Access Compliance Report

Public Rights-of-Way

(Curb Ramps)

Intersection ID: 50540	Main Street: DANIEL_DWAYNE_DR	Cross Street: LEMONGRASS_LN	Location: NW
ADA ID: 48D95FC8FD65	Ramp Type: PerpDiag	Initial Pass/Fail: Fail	Overall Compliance: No
Codes/Mitigation Info/Possible Solution		Field Measurements/Component Compliance	
Severity Score: 10

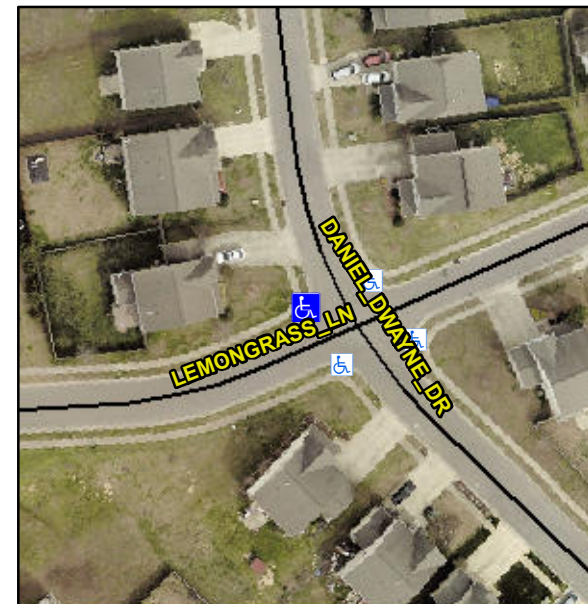
Not Found, R304.5.1, R304.5.3

Compliance	Description	Data	Compliance	Description	Data
N/A	Ramp Length (in)	48.0	Yes	Ramp Slope (%)	7.1
No	Ramp Width (in)	47.0	No	Ramp XSlope (%)	2.6
N/A	Flare Type LT	N/A	N/A	Flare Type RT	N/A
N/A	Flare Slope LT (%)	N/A	N/A	Flare Slope RT (%)	N/A
N/A	Flare Traversable LT?	N/A	N/A	Flare Traversable RT?	N/A
N/A	Landing Length (in)	N/A	N/A	DWS Provided?	N/A
N/A	Landing Width (in)	N/A	N/A	DWS Contrast?	N/A
N/A	Landing Slope (%)	N/A	N/A	DWS Length (in)	N/A
N/A	Landing X Slope (%)	N/A	N/A	DWS Full Width?	N/A
N/A	Landing Curb? (Y/N)	N/A	N/A	DWS Offset (in)	N/A
N/A	Shared Landing?	N/A			
N/A	Gutter Ponding?	N/A	N/A	Gutter Slope (%)	N/A
N/A	Gutter Lip Ht (in)	N/A	N/A	Gutter X Slope (%)	N/A
N/A	Painted X Walk1?	No	N/A	Painted X Walk2?	No
	X Walk 1 Direction	To S		X Walk 2 Direction	To E
N/A	X Walk 1 Width (in)	N/A	N/A	X Walk 2 Width (in)	N/A
	X Walk 1 Slope (%)	4.0		X Walk 2 Slope (%)	0.2
	X Walk 1 X Slope (%)	1.1		X Walk 2 X Slope (%)	3.0

Remove & Replace Curb Ramp With Two New Directional Ramps or Equivalent.
